THE POOL HOUSE PROJECT

ELEVATION FRONT AND LEFT

Reviewed by: Alvaro Polanco, Building Inspector Supervisor. (P) 859.258.3244

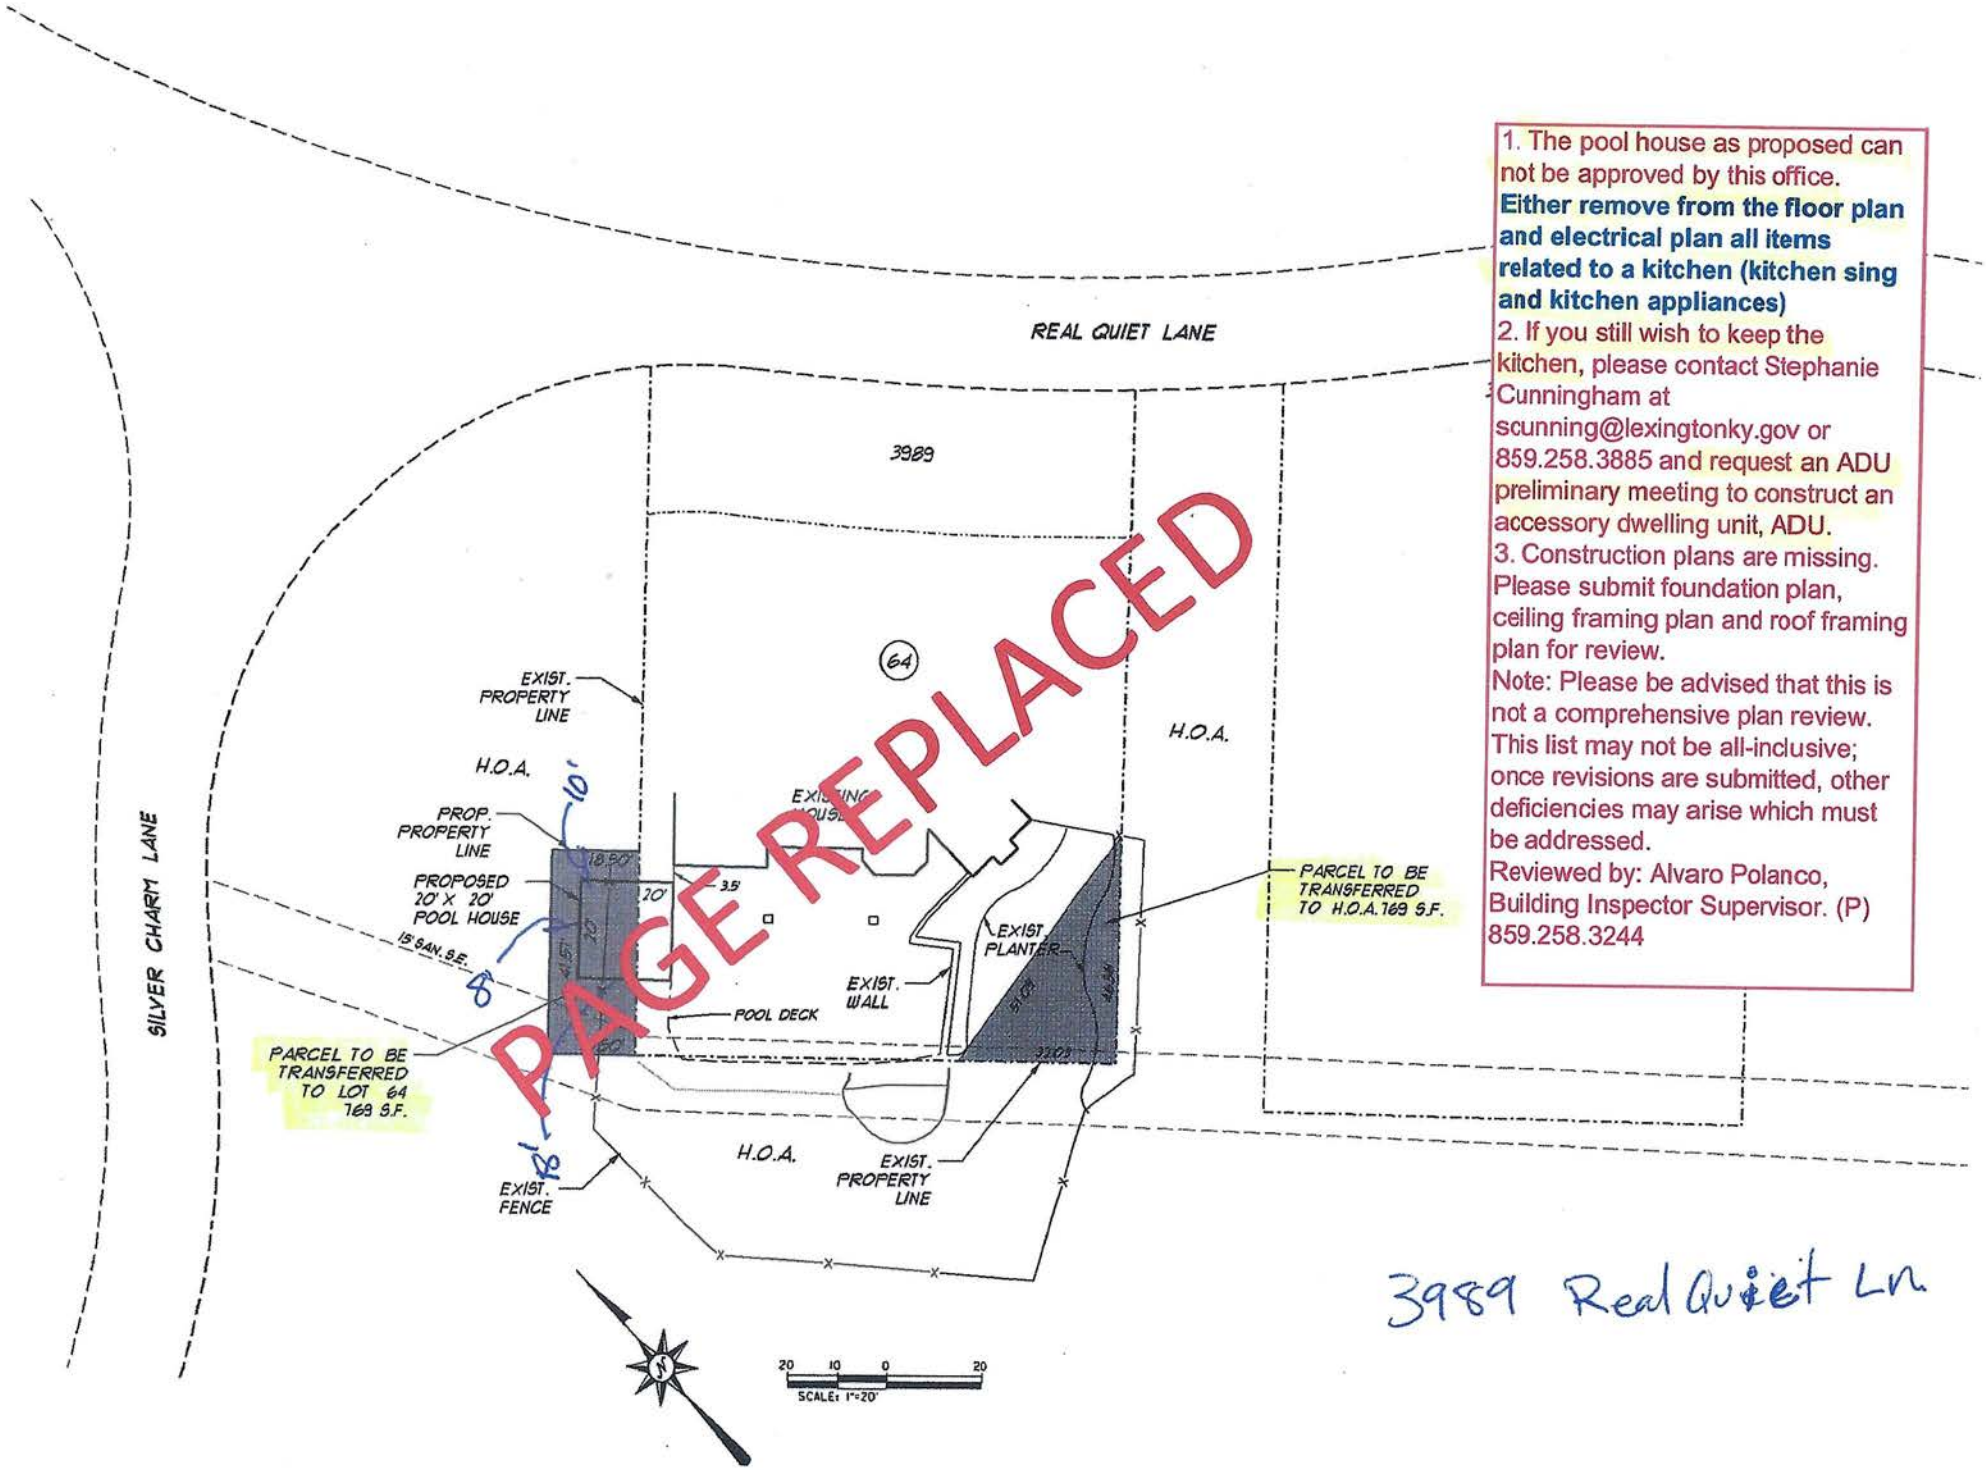
1. The pool house as proposed can not be approved by this office. **Either remove from the floor plan and electrical plan all items related to a kitchen (kitchen sing and kitchen appliances)**
2. If you still wish to keep the kitchen, please contact Stephanie Cunningham at scunning@lexingtonky.gov or 859.258.3885 and request an ADU preliminary meeting to construct an accessory dwelling unit, ADU.
3. Construction plans are missing. Please submit foundation plan, ceiling framing plan and roof framing plan for review.

SCOPE OF WORK"
Detached POOL House
NO KITCHEN APPLIANCES OR KITCHEN SINK.
-
CONDITIONS:
- Per zoning regulations the proposed bathroom can only have access from the exterior of the pool house if "(...) A wet bar, including a single sink with a waste drain and a refrigerator (...)" are installed.
- NOTE: A Counter-top and under cabinets are proposed ONLY. No Kitchen appliances or Kitchen sink.

THE POOL HOUSE PROJECT
FIRST FLOOR PLAN

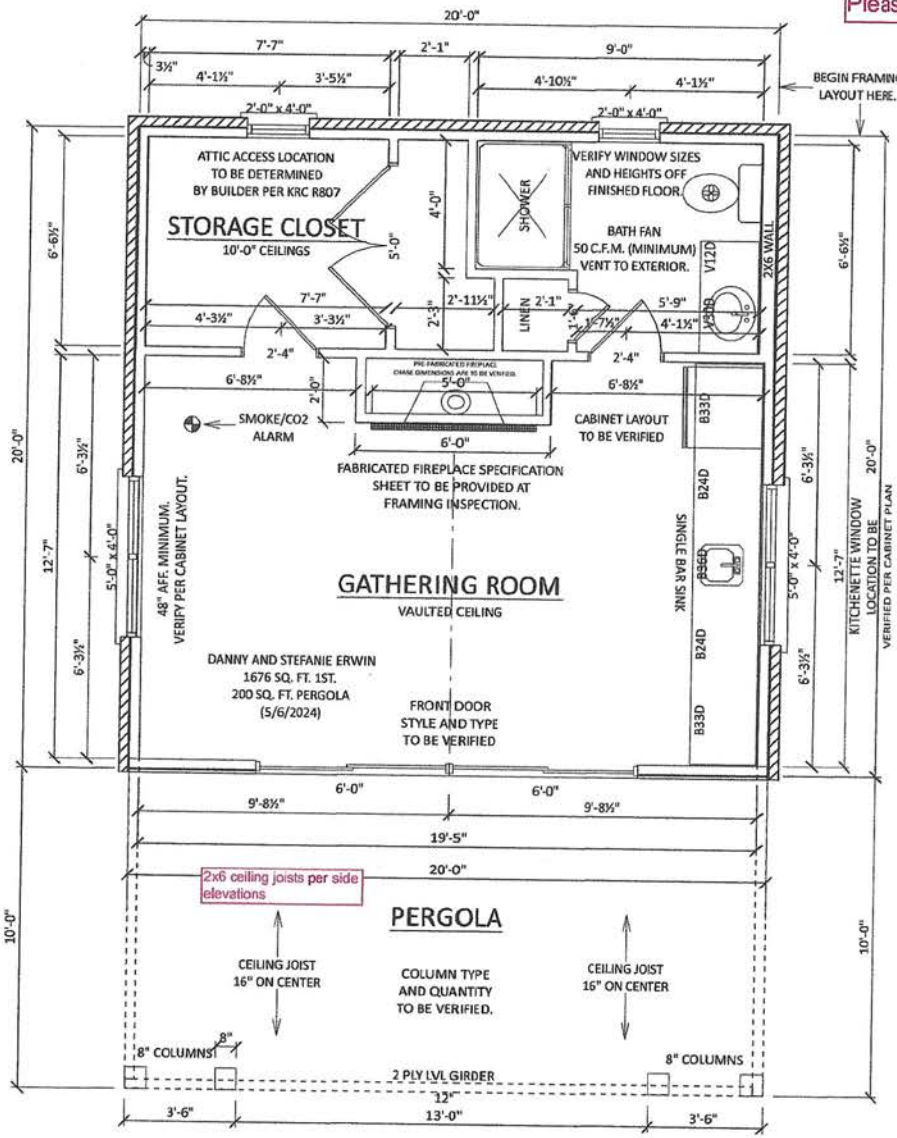
Tempered glass is required on window by shower. Please revise.

Per zoning regulations the proposed bathroom can only have access from the exterior of the pool house. Please revise.

The roof plan calls for roof trusses and the first floor plan calls for a vaulted ceiling above the gathering room. Please submit the roof truss cut sheets or the truss package. If stick frame is proposed, please note that the proposed vaulted ceiling requires an engineered ridge beam sized by the lumber company's software or by a KY licensed design professional. The end of the ridge beam shall be posted directly to foundation or to a beam designed to receive the concentrated roof loads. If stick frame, please submit the engineered ridge beam and the specs of the beam supporting the ridge beam or a detail depicting loads being transferred to foundation.
